Staff Report for Item 12b

Application Number: H16-03-0020

Address: #820 Carsten Lane

Demolition of non-historic second floor rear addition. Partial demolition of southwest wall and demolition of exterior staircase.

1962 Sanborn Map

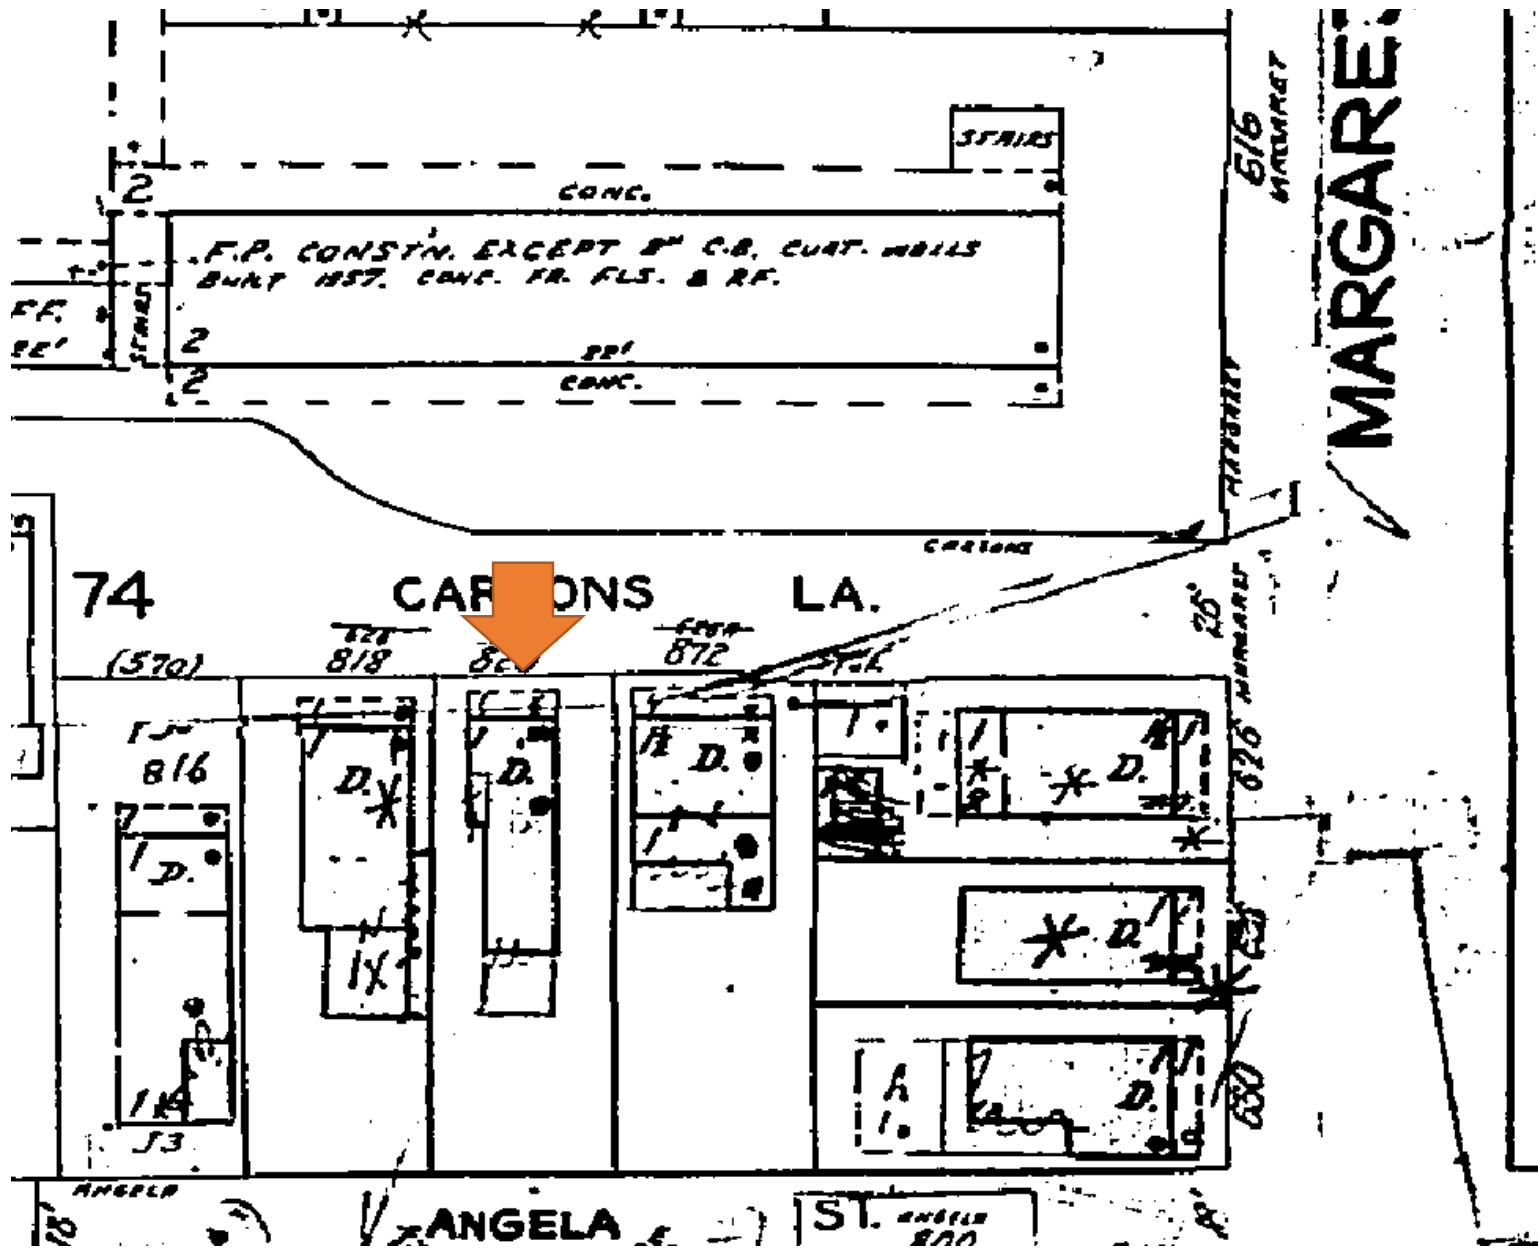
on the 1962 Sanborn map, which makes it historic. Even though the wall looks to be historic, according to the 1962 Sanborn map, staff does not feel that it meets any of the criteria listed in Sec. 102-218, and therefore can be considered for demolition:

EXISTING PLAN

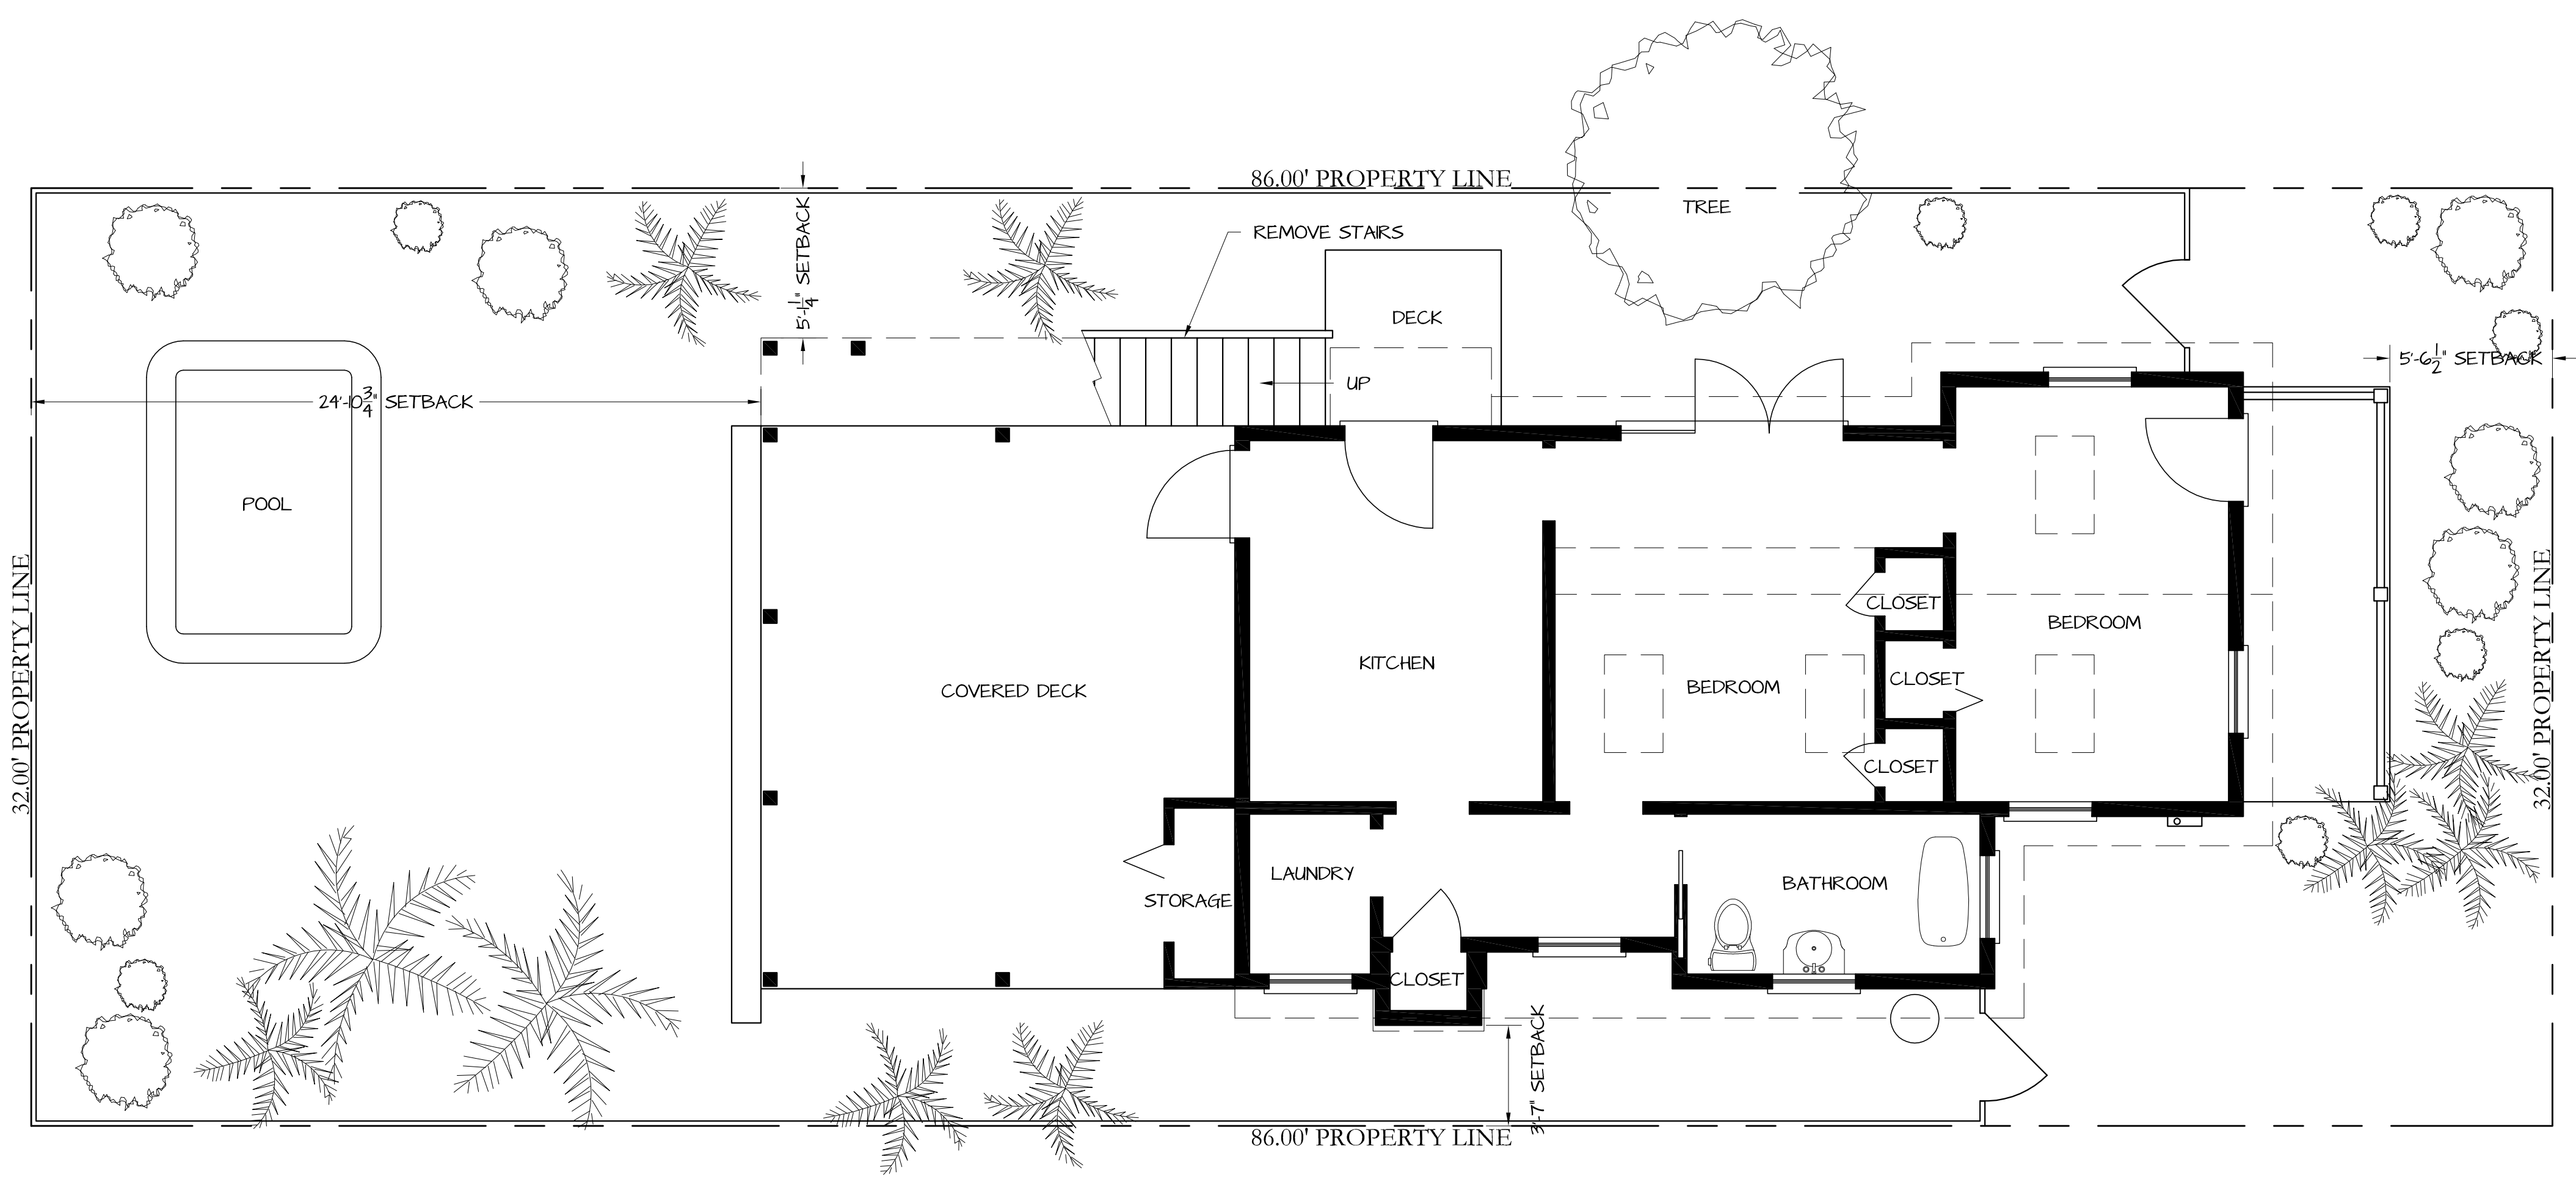
This Certificate of Appropriateness proposes the demolition of a non-historic exterior staircase, a non-historic second floor addition, and part of the wall along the southwest side of the building. The staircase and addition were built in 2007 and the wall on that side of the building might appear

Staff believes the demolition of the second floor addition and staircase will not result in the following items:

- (1) The demolition will not diminish the overall historic character of a district or neighborhood;
- (2) Nor will it destroy the historic relationship between buildings or structures and open space.
- (3) This demolition will not affect the front building façade.
- (4) Staff does not believe elements that are proposed to be demolished will qualify as contributing as set forth in Sec. 1021-62(3).
